D1.0 Precoding Figure modifications

IEEE P802.3ca 100G-EPON Task Force Meeting, Pittsburgh, PA May, 2018

Precoding Figures in D1.0 & ambiguities

Powell_3ca_1_0318

Figure 142-7—Differential encoding

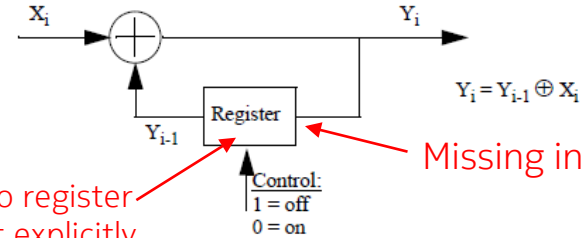
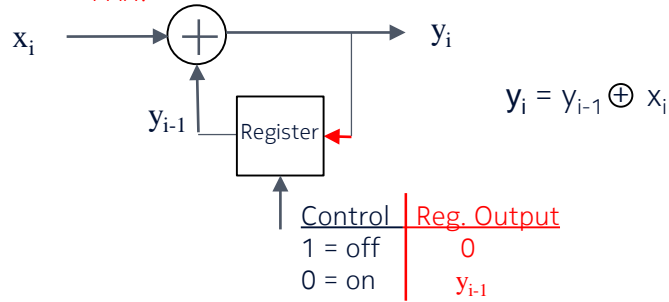
No "R" on Reg. so register output state not explicitly linked to control

Missing input arrow

- Ambiguities exist in the current D1.0 PMA precoding figures

X_i = Input from OLT PCS FEC encoder
 Y_i = Output to OLT **PCS gearbox**
PMA?

- Proposed figure modifications shown in Red clarify the ambiguities

Figure 142-8—Differential decoding

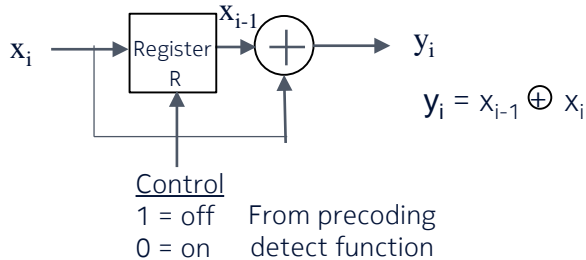
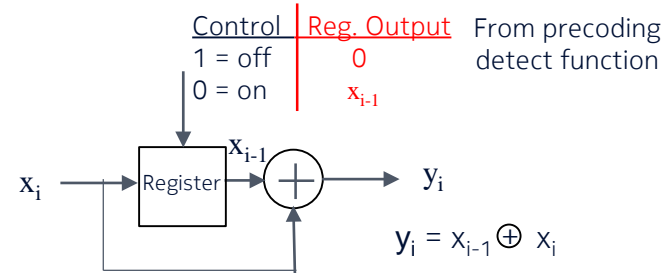
No "R" on Reg. so register output state not explicitly linked to control
